Work Order ID 92707

Item Name: Crosstube Fwd High

DRAWING NO. D212-664-141	TITLE XTUBE ASSY (205/212/412 HI FWD)	REV. D	DART AEROSPACE LTD ENGINEERING ORDER		D.E.O. NO. D212-664-141-D-1	SHEET NO. SHEET 1 OF 2	SCALE NTS
DRAWN	CHECKED	MFG. APPR.	APPROVED	DE APPR.			
DATE 11.04.07	DATE 11.04.11	DATE 11.04.12	DATE 11/04/12	DATE 11.04.12

DRAWING NO. D212-664-141	TITLE CROSSTUBE ASS'Y (205 HI FWD)	REV. D	DART AEROSPACE LTD ENGINEERING ORDER		D.E.O. NO. D212-664-141-D-2	SHEET NO. SHEET 1 OF 1	SCALE NTS
DRAWN <i>UP</i>	CHECKED <i>ASS</i>	MFG. APPR <i>AS</i>	APPROVED <i>MD</i>	DE APPR. <i>TH</i>			
DATE 11.07.15	DATE 11.07.20	DATE 11.07.21	DATE 11/07/21	DATE 11.07.21

**D212-664-141/-141B
ASSEMBLY DETAIL**

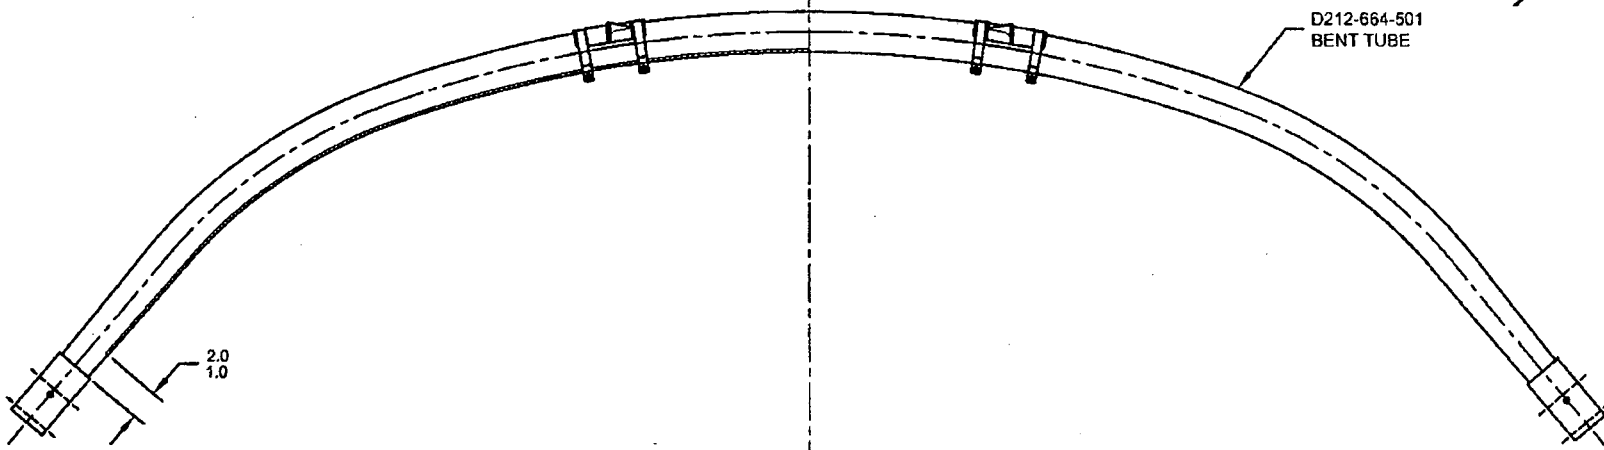
PURPOSE:

ADD AN INSPECTION WINDOW TO UNDERSIDE OF CROSSTUBE.

NOTES 2 OF SHEET 1 IS AMENDED AS FOLLOWS:

IS:

WAS:

MASK AREA PRIOR TO PAINTING.
REMOVE MASKING AFTER PAINT
AND APPLY CLEAR COAT
